Technical bulletin 197 μFLO^{G4} and XFC^{G4} 6200/6201EX system reset and RTD input performance deviation

Totalflow products	Doc name: Technical bulletin 197
File name: 2104820TBAB-TB197.docx	Document Title: μFLO ^{G4} and XFC ^{G4} 6200/6201EX system resets and RTD input performance deviation
Distribution: External public	Issued by department: Totalflow customer service
Date: 3/14/2013	Language: En
Revision: AB	Creator name: USJAEST
Page: 1/24	Contact: +1 918.338.4888 or 800.442.3097 (opt. 2)
Status of document: Released

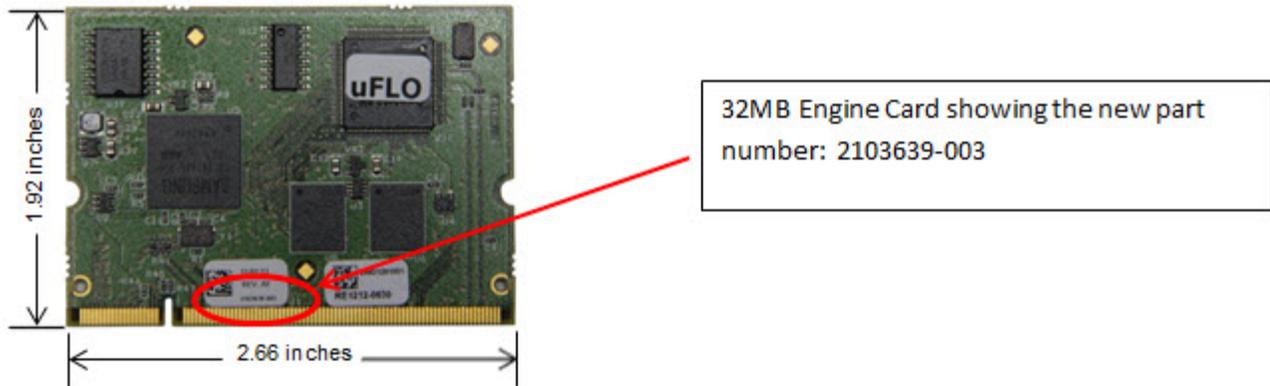
The voltage regulator was replaced on the 32MB engine card. The modified engine card has been thoroughly tested over temperature and does not exhibit the voltage drop at reduced operating temperatures that the previously used regulator exhibited. This voltage drop was the root cause of the 32MB engine card system resets that were randomly observed and has been resolved with the newly modified engine card. The new engine card may be identified by part number 2103639-003 or greater on the card itself. Each card will also have a sticker indicating the hardware platform that it is designed for. The new engine shown card below reflects that it is the new part and is for a μFLO^{G4}.

The software (operating system and flash) has also been updated and is installed on the appropriate engine cards. Users will be able to identify any units that may have this upgrade installed by referring to the attached sticker and verifying the part number to be 2103639-003 or greater.

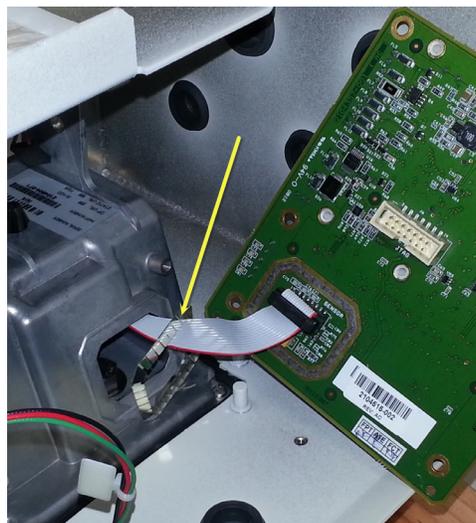
5. Upon removal of the board, you may find 2 conditions that need to be corrected.
 - a. The EMI shield may be loose. This must be repositioned and snapped into place. Improper or incomplete installation of the gasket may result in shorting of components on the board, causing invalid readings for any or all DP, SP, and RTD values. This could also result in the permanent failure of this board.

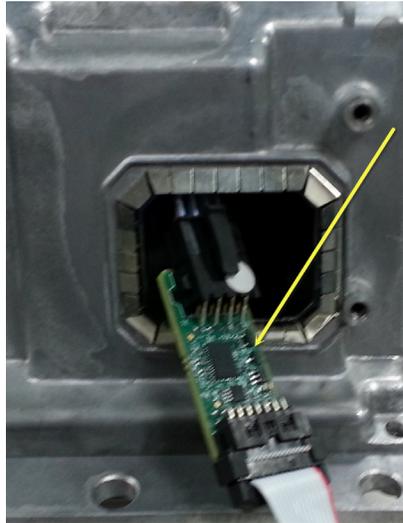
- b. The Stamp Card may have come loose from its internal retaining clip. If this is the case then follow step 6; otherwise, proceed to step 7. If the half round clip is still attached to the loose board it may be very carefully removed so as not to damage the board or its components and may be discarded prior to step 7.
